U.S. NUCLEAR REGULATORY COMMISSION

Report Nos: 50-390/99-08, 50-391/99-08

Facility: Watts Bar, Units 1 and 2

SUBJECT: SAFETY EVALUATION IN RESPONSE TO A REGION II TASK
INTERFACE AGREEMENT - WATTS BAR NUCLEAR PLANT -
EVALUATION OF ICE CONDENSER BASKET SCREWS

FIGURE 1 - ICE BASKET COLUMN - ELEVATION VIEW

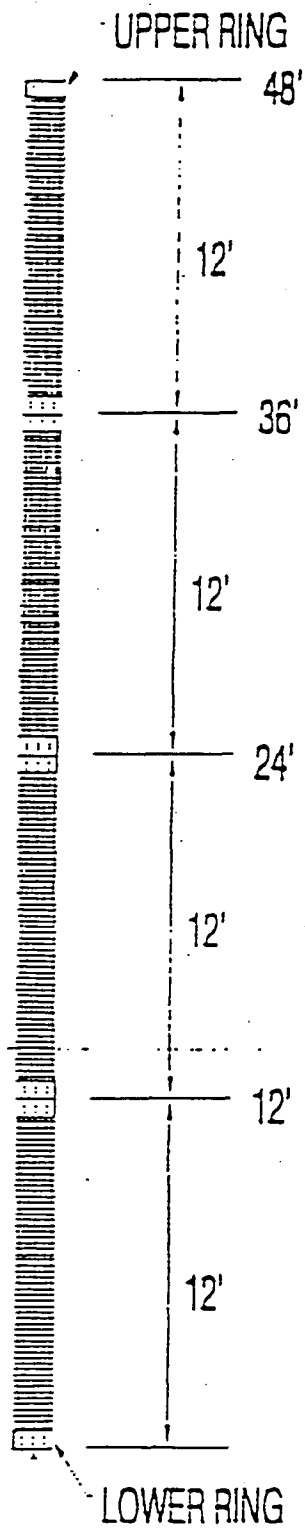
The Watts Bar Nuclear Power Plant (WBN) is an ice condenser plant with 24 ice condenser bays located 300° around the containment. Each bay holds 81 ice condenser baskets for a total of 1944 ice condenser baskets. Each ice condenser basket consists of four 12-foot long sections joined together as shown in Figure 1. Each ice condenser basket has a top ring with six pairs of screws at 60° intervals. The top ring provides a load path for servicing such as ice weighing operations. There are three intermediate joints that connect the 12-foot sections together. There are six pairs of screws at 60° intervals on the top section-to-coupling and six pairs of screws at 60° intervals on the bottom section-to-coupling. The intermediate joints must resist separation loads incurred during a design basis accident. The bottom ring has six pairs of screws at 60° intervals. The bottom ring restrains axial loads during accident conditions.

FIGURE 2 - TEST SPECIMEN SIDE VIEW

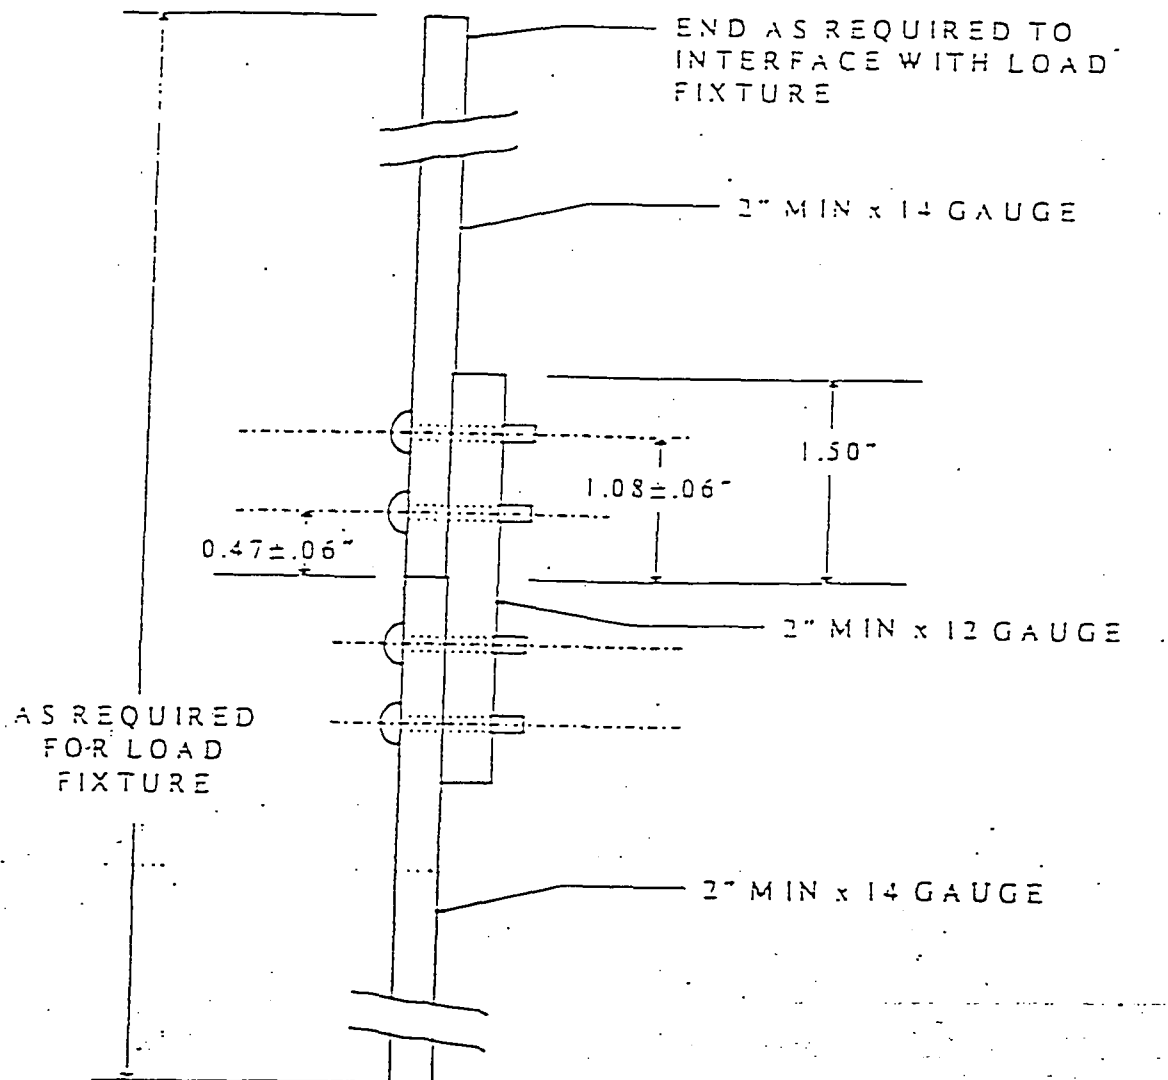
The licensee at WBN conducted shear tests on splice joint specimens containing two screws on each side of the splice as shown in Figure 2. Five splice joint specimens were assembled using screws randomly selected from the WBN warehouse and 20 specimens were assembled using screws randomly selected and removed from the ice condenser baskets. The maximum loads were determined by applying a shear load to the specimen and measuring the maximum load required to break the joint. The results were fairly consistent with the exception of one outlier that failed at a significantly lower load compared to the other results.

The licensee observed an outlier in the sample of 20 tests with no explanations why the outlier occurred. The licensee stated that the maximum failure load for the outlier exceeds the acceptance criteria and that the outlier could support design and accident loadings. Therefore, no additional action is required by TVA with regard to the outlier.
